**External Envelope:
Glass & Aluminium and
Stone Façade Elements**

CADENZA METROLINK INTERFACE

Cadenza, Earlsfort Terrace, Dublin

**Document No:
1087-BDA-XX-ZZ-RP-Y-0001-C02**

Figure 10 Plan of Cadenza with TII predicted ground settlement. Max. settlement is now predicted as 19.45mm

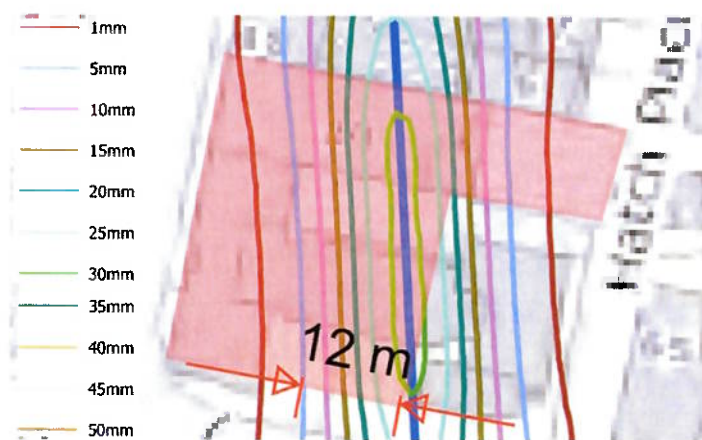
MetroLink has assessed the predicted "Settlement" and presents its findings on drawing no. ML1-JAI- EIA-ROUT-XX-DR-Y-21146 rev P02. This drawing indicates MetroLink will be causing a 30mm settlement directly under the location of our client's building which is unacceptable. We have not received an update of this drawing.

The new document 'Addendum to the EIAR – Downward Tunnel Realignment: St Stephen's Green Station to Charlemont Station (P01 06.03.2024)' indicates a revised settlement of maximum 19.45mm. Settlements of this magnitude cannot be accommodated by the building's facades. Such settlement, particularly if introducing differential settlement between columns, will cause damage.

Figure 13 EWS-001 Plan view, glass-to-glass corner condition adjacent to Gridline D, South elevation.

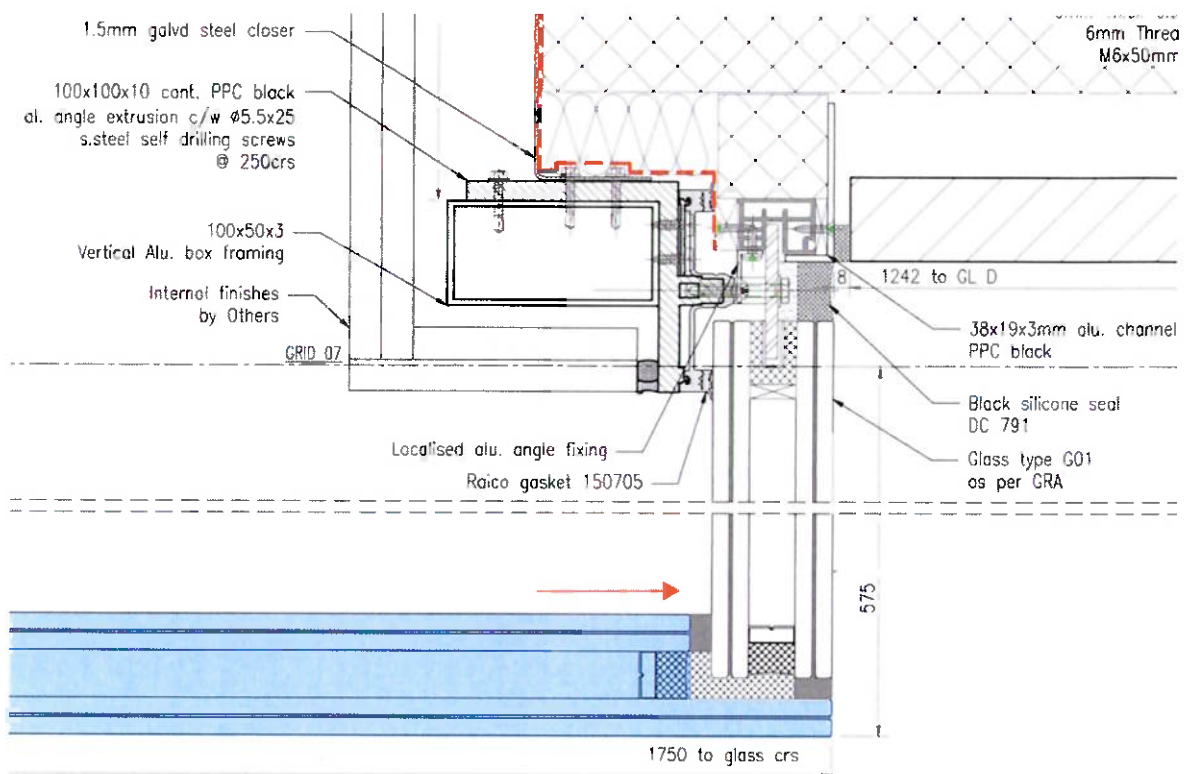
The vertical joint between double-glazed panels consists of 28mm silicone pointing with a 25mm PVC drainage tube. The silicone pointing can take small amounts of compression and tension. The PVC tube can accommodate small amounts of compression. If one column settles differentially, the glass panels either side of that column will rotate in plane compressing the silicone seal.

Due to the aspect ratio of the panels closest to gridline D on the South elevation, the TII predicted differential settlement of 19.5mm from Gridline C to D would result in 1.75m wide panels rotating in plane not less than 2.8mm at their base. As each panel is 3.5m tall this translates into 5.3mm rotation at the top corner of the panel. Such rotation would exceed the design parameters of the structural sealant at the glass to glass joint crushing and tearing the sealant and inducing stress in the glass. It may not cause breakage but will apply long-term stress into the structural sealant joint which may cause failure of the structural connection.

Figure 17 EWS 002 partial South elevation. Differential settlement of structure at Gridline D

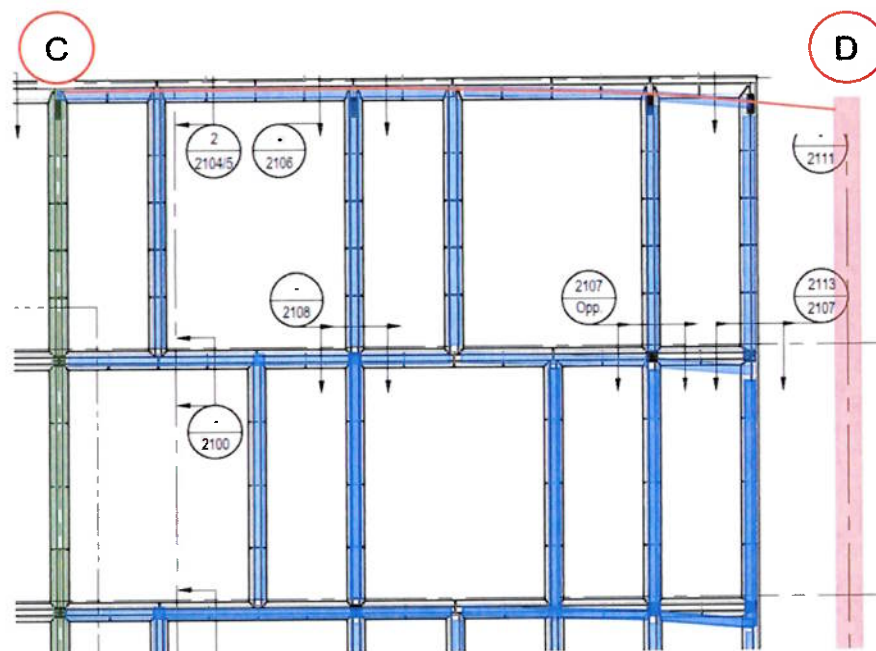
The diagram below looks to illustrate the effects of differential settlement of the column at Gridline D. As the Level 5 slab deflects, the veil goes out of square.

The differential settlement of a column causes rotation of the connection between horizontal and vertical veil elements. These connections are typically formed with countersunk fixings tapped into a block of stainless steel. These connections were not designed to accommodate significant rotation. Detailed analysis would be required to determine how these connections react and

whether the horizontal beams of the veil would rotate at these connections or be forced to go into bending ('S' shaped bend on elevation). If over-stressed the connections could fail.

If the horizontal beams or vertical mullions go into bending due to differential settlement, this could cause over-stressing of the fixings in the stone exceeding permissible safety factors and/or causing cracking of the stone.

In a worst case scenario this could result in pieces of stone falling onto the public pavement below.

Figure 19 EWS-003 South elevation. Deformation due to ground settlement

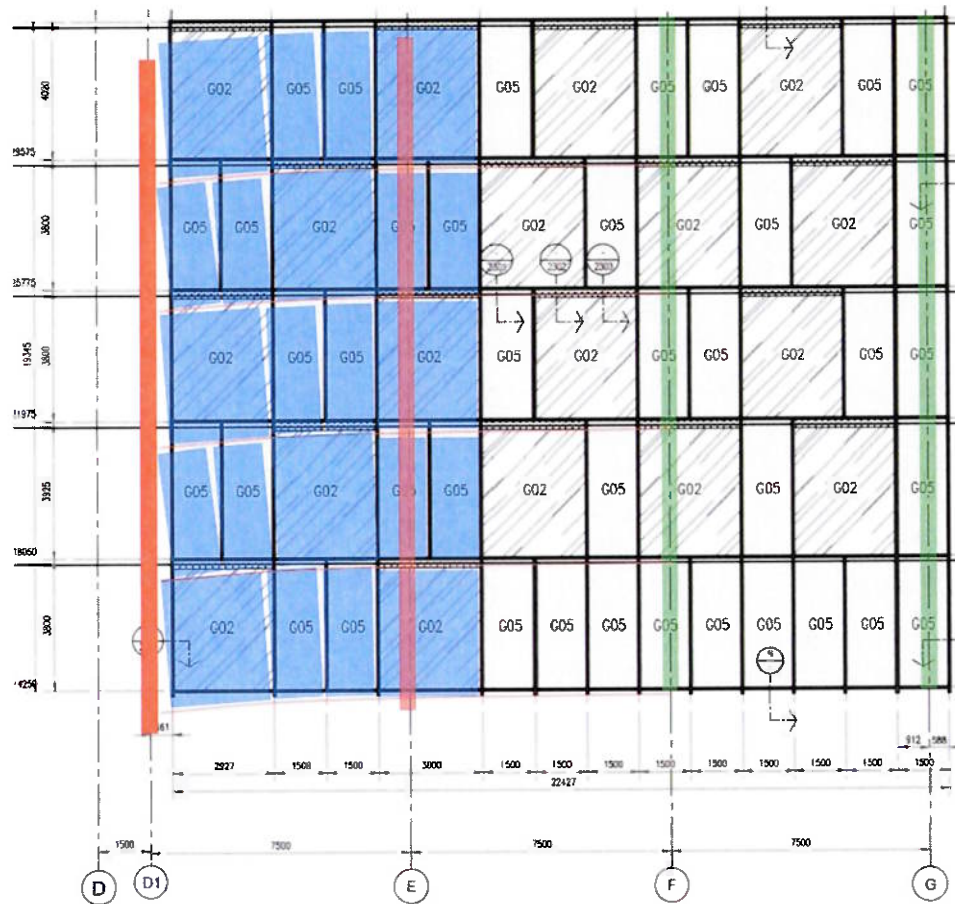
According to the TII's document EIAR Appendix 5.17 Building Damage Report page 126 of 158 and 'Addendum to the EIAR – Downward Tunnel Realignment: St Stephen's Green Station to Charlemont Station (P01 06.03.2024)' the South elevation of EWS-003 will suffer differential settlement of approximately 19.5mm from one side of the screen to the other in the final condition. A similar differential deflection will occur along the Eastern EWS-003 façade during the tunnelling operation as the building's structure deforms.

The curtain wall system has very little capacity for racking of the glass on elevation. When the structure moves differentially as per the diagram above, the mullions remain vertical and the transoms rotate in plane. As each glass unit sits on a transom, the glass rotates with the transom. Based on the TII EIAR addendum there is approximately 19.5mm of differential settlement across quite a small width of approximately 10m.

Due to the aspect ratio of the panels closest to gridline D1 on the South elevation, and along the Eastern elevation, the TII predicted differential settlement of 19.5mm in this area would result in 1.5m wide panels rotating in plane not less than 2.9mm at their base. As each panel is 3.8m tall this translates into 7mm rotation at the top corner of the panel. The toggle glazed system does not have capacity for this degree of movement. The mullion detail below shows the proximity of glass to metal. If the glass rotates too far, the inner glass impacts the aluminium mullion profile causing breakage. The design gap, including glass tolerances and installation tolerances would be estimated as between 2mm and 6mm.

Figure 25 EWS-006 Horizontal displacement due to vertical deflection of Level G slab.

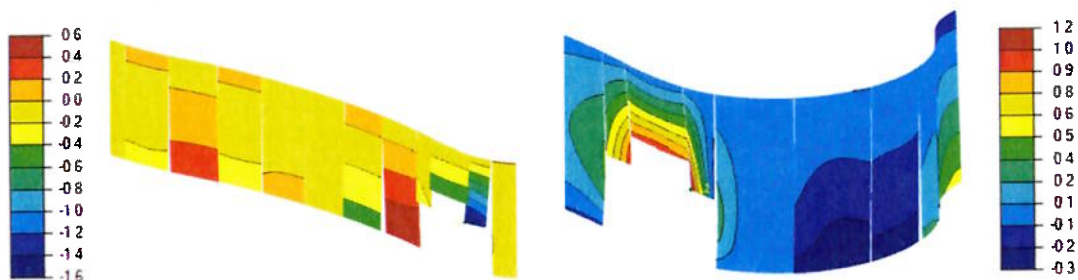
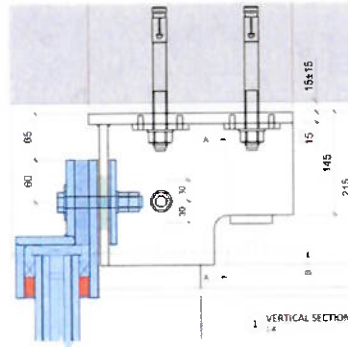
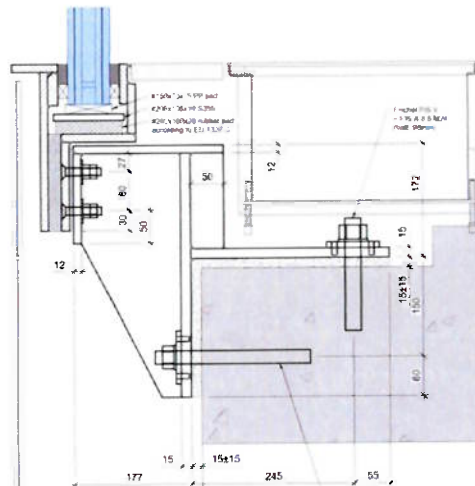
The differential deflection of the slab due to the design loads has been reviewed, and the in-plane rotation/deflection of each individual panel plotted. Although the worst case vertical displacement is on the South, the worst-case rotation due to differential deflection across the width of a single panel, occurs on the West elevation. This is illustrated in the diagram below.

Figure 28 EWS-600 Plan detail of glass to glass joint with steel fin

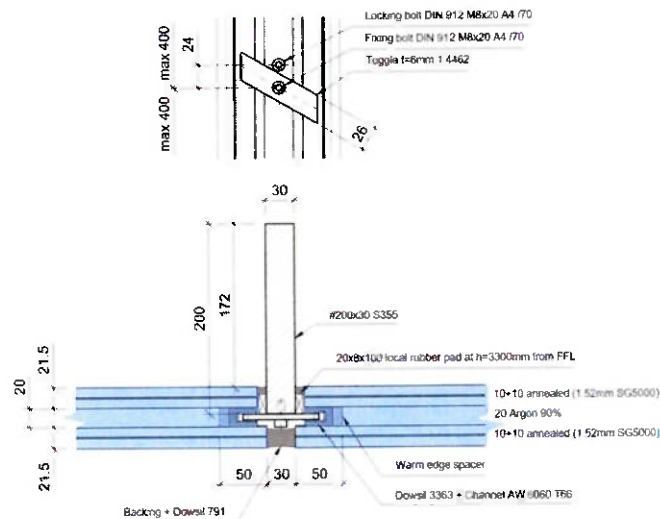
The glazing system has vertical fins between each double glazed unit. The fin is intended to provide resistance to wind load but has limited capacity to resist lateral in-plane loads. As can be seen in the diagram below, **should the glass restraint at the head fail and the glass rotate in plane, there is a high risk the perimeter internal silicone seal would be crushed resulting in glass to metal contact.**

Should settlement due to MetroLink works cause the Level G slab deflect more than anticipated in the current design, it is possible the permissible long-term shear load in the structural silicone at the head detail will be exceeded. If the head restraint were to fail, allowing the panel of glass to rotate in plane (along the elevation), there is a high risk of glass breakage due to metal to glass contact and/or glass to glass contact.

It is also possible the concentration of load on one deadload support at the base of the glass would over-stress the glass causing failure.
